**निविदा सूचना शुद्धि पत्र/ CORRIGENDUM to Tender Document for Supply, Installation and Commissioning of SCRUBBER SYSTEM**

**(Tender Reference No. : SROL/PUR/SS/01)**

This is to bring to the notice of all concerned that in the tender floated on 28 04 2017 the specification given at Annexure -3 and the Technical compliance statement given at Annexure-4 are revised as follows.

## Annexure3

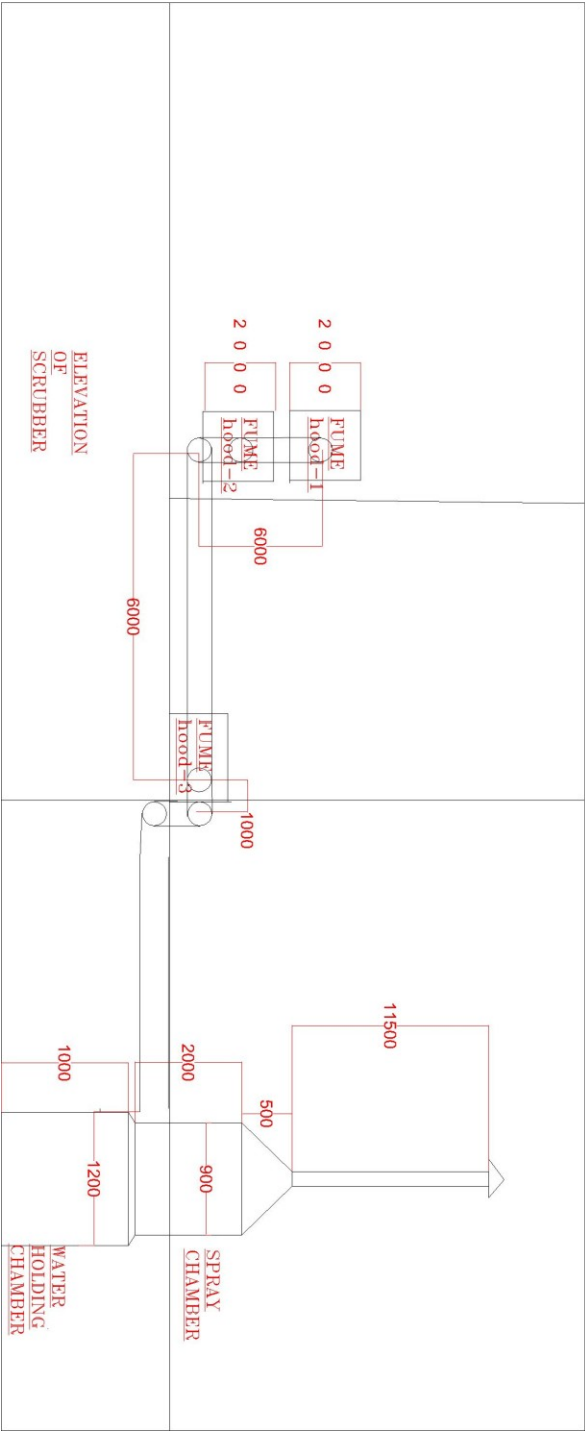
<b>S. No.</b> <b>(1)</b>	<b>Component</b> <b>(2)</b>	<b>Requirement</b> <b>(3)</b>
1	Scrubber unit	<ul style="list-style-type: none"> <li>• The absorption/spray portion of scrubber unit should have a diameter of 900 mm (ID) and height of 2000 mm.</li> <li>• The base of scrubber (water holding portion) should be of dia 1200 mm (ID) and height 1000 mm.</li> <li>• The Scrubber should be of acid resistant PP + FRP material for strength and structural stability.</li> <li>• Thickness of PP portion should be 5 mm minimum and FRP coating should be 5 mm minimum.</li> </ul>

2.	Scrubber liquid	<ul style="list-style-type: none"> <li>• The Scrubber should have water circulation system which will absorb acid fumes coming from the Fume cupboards.</li> <li>• A level controller should be provided that opens and closes a water makeup valve and liquid level indicator to maintain the liquid level in the scrubber.</li> </ul>

3.	Drain facility	<ul style="list-style-type: none"> <li>• Provision should be made in the scrubber for neutralizing chemical feed.</li> <li>• Scrubber should be provided with a blow down valve to drain the concentrated/neutralized liquid.</li> </ul>

4.	Water pump	<ul style="list-style-type: none"> <li>• The pump should be of PP fitted with 0.75 KW motor.</li> </ul>
5.	Chimney	<ul style="list-style-type: none"> <li>• The Scrubber outlet should be fitted with a vertical duct made of PP (Minimum 3 mm) + FRP (Minimum 3 mm) material of 12000 mm height (approximately) and dia of 400 mm (ID) minimum. This will serve as the chimney.</li> <li>• The outlet of chimney should be at least 4000 mm above the roof top of the laboratory.</li> </ul>

<ul style="list-style-type: none"> <li>The outlet of chimney should be covered in such a manner to prevent inflow of outside water/dust in to chimney.</li> </ul>

6.	Blower unit	<ul style="list-style-type: none"> <li>The Blower unit should have Impeller made of FRP material and casing of PP + FRP.</li> <li>It should be mounted on a 5 HP, 1400 RPM, 3 Phase Motor shaft.</li> <li>The Blower should be connected to the outlet of the Scrubber</li> </ul>

7.	Ducts	<ul style="list-style-type: none"> <li>Ducting has to be provided to connect three fume hoods to the scrubber.</li> <li>The exhaust pipes of all the three fume hoods should be of FRP, 200 mm (ID) minimum.</li> <li>The exhaust pipes from the all the three fume hoods should be connected to a single common main duct of FRP material, 300 mm (ID) minimum.</li> <li>Thickness of ducting pipes should be 4.0 mm minimum.</li> </ul>

8.	Dampers	<ul style="list-style-type: none"> <li>A suitable damper at the outlet of each fume hood should be provided to prevent back flow of fumes to the fume hood which is/are not in operation at a particular time.</li> </ul>

9.	Position of scrubber and blower unit	<ul style="list-style-type: none"> <li>The Blower unit and the Scrubber unit shall be positioned on the ground level near the rear entrance of the laboratory building. (Opposite to Mechanical Workshop).</li> </ul>
10	Civil Work	<ul style="list-style-type: none"> <li>All Civil work for installation and commissioning of the scrubber system shall be done by the bidder.</li> </ul>
